Docket No. 50-336
File Nos. RI-90-A-180, RI-90-A-198

Subject: Allegations Concerning (1) Wide Range Nuclear Instrumentation Operability, (2) Operator Attentiveness, and (3) Alignment of Reactor Coolant Flow Transmitters.

CONCERNS FROM A NORTHEAST EMPLOYEE

FIGURE B 5
NJTC PROBE ASSEMBLY MT-2

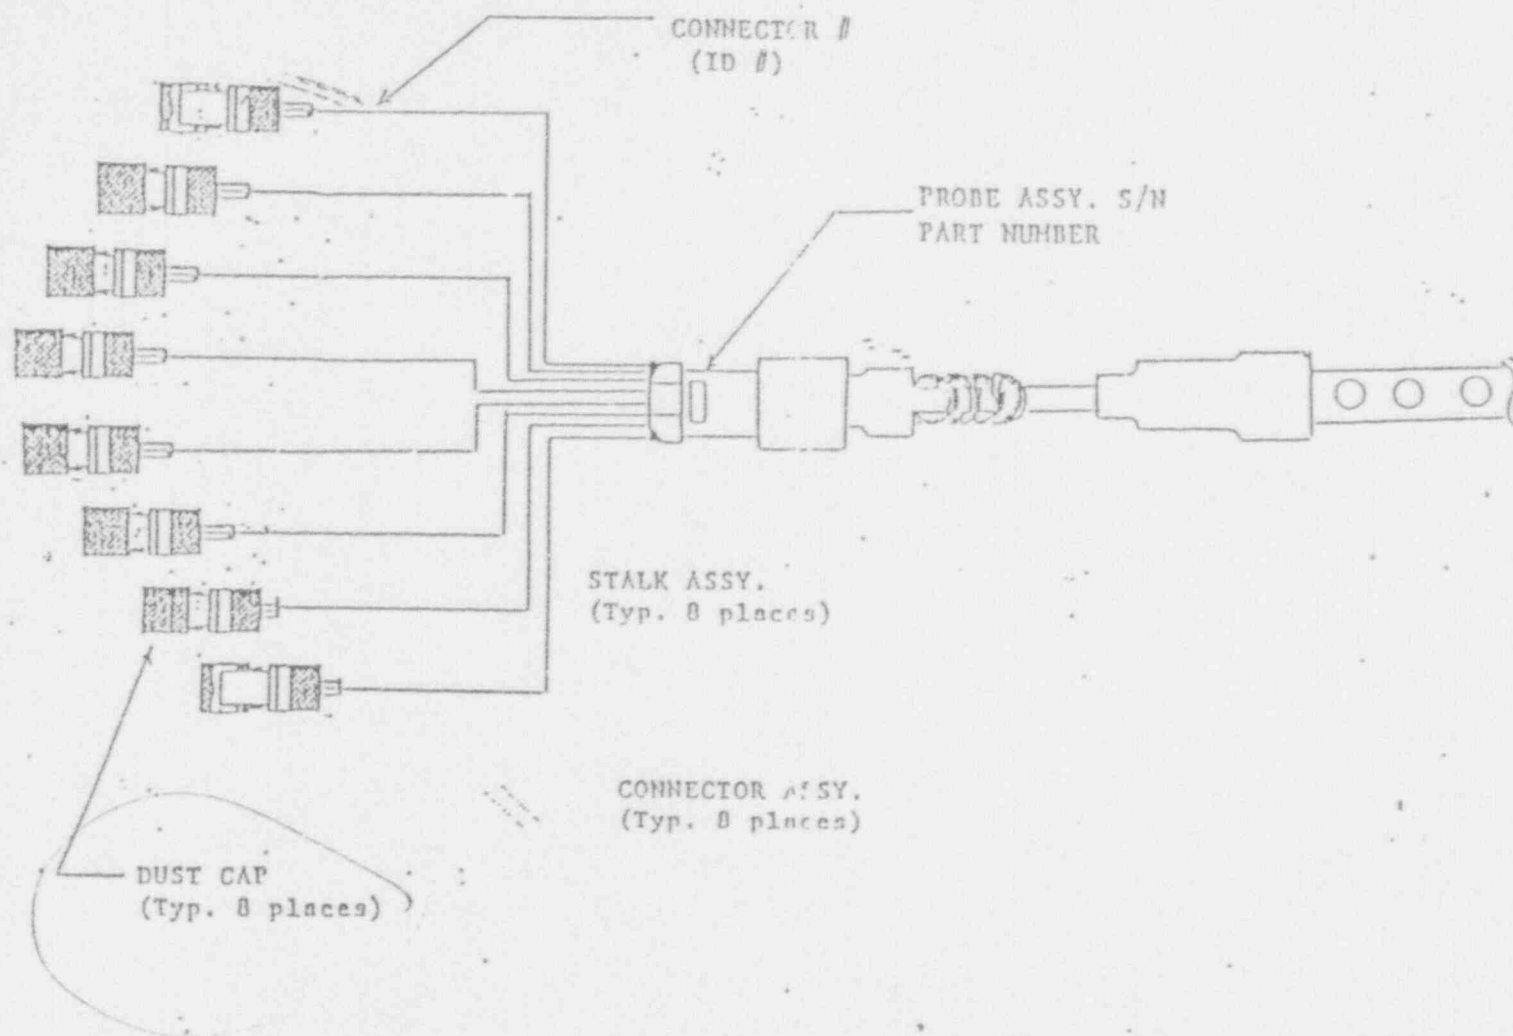
e. According to the allegor dust covers are installed on the HJTC connectors when disconnected as depicted on procedure figure B.5 of IC2421C. Inspector review of procedure IC 2421C section 5.5.6 on reconnection of connections did not identify a specific procedural step to remove dust covers on the connectors.
